IFB 2025-05

Hagatna Wastewater Treatment Plant Clarifier Parts

This addendum serves to revise the previously issued bid documents and/or provides additional information for informational purposes. In cases where the responses below result in modifications to the bid documents, please consider them as amendments to the original IFB.

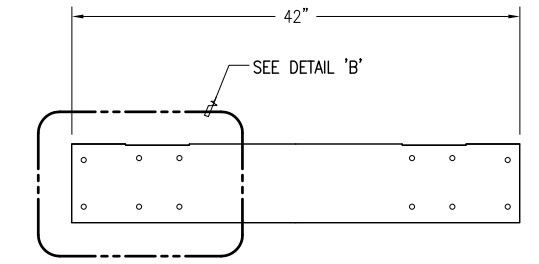
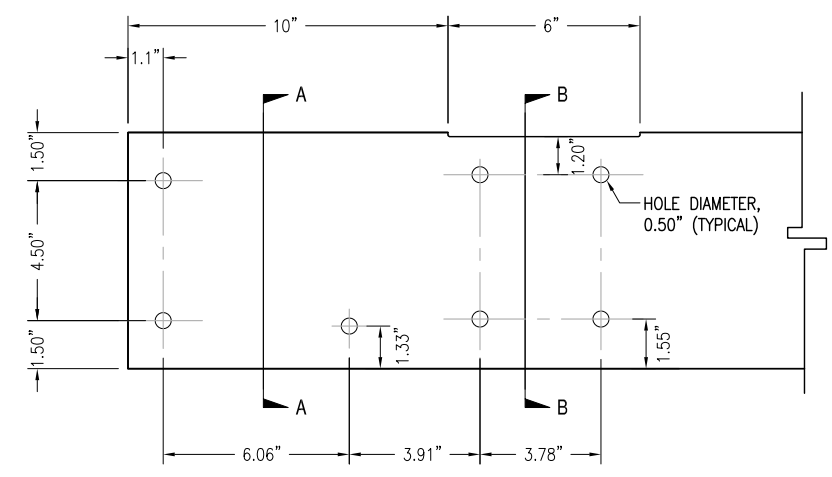
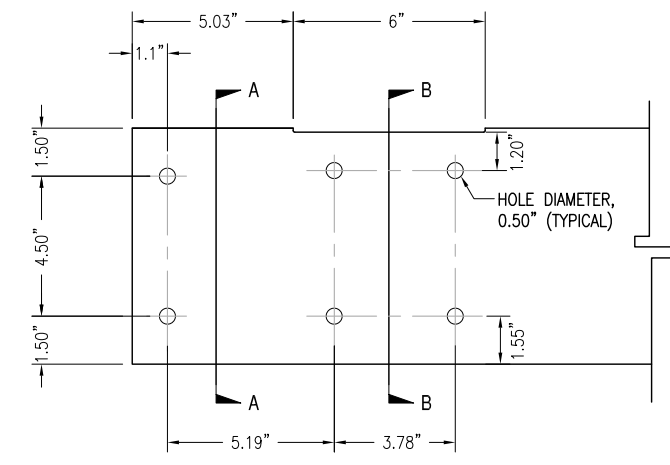
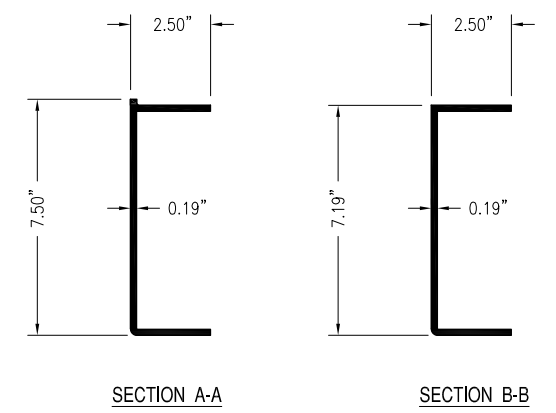
2.	<p>Section 1 – Bid Items (Page 6 of 45)</p> <ul style="list-style-type: none"> Items 1 and 2 (scraper flights) typically require mounting holes and cutouts for wear shoes to be included. However, no drawings were included to confirm they are to come that way. It is also customary to order these as cut to length only without any holes or cutouts so plant personnel can modify them to suit. These are called “blanks”, as they have no holes. Please confirm what condition these flights are to come in: ready to install or as “blanks.” If ready to install, please provide drawings of the current flights so we can price in the required number of holes and cutouts. 	<p>The condition of the flights should be ready to install. Please follow the specifications provided in the bid and refer to the shop drawing in this RFI response.</p>
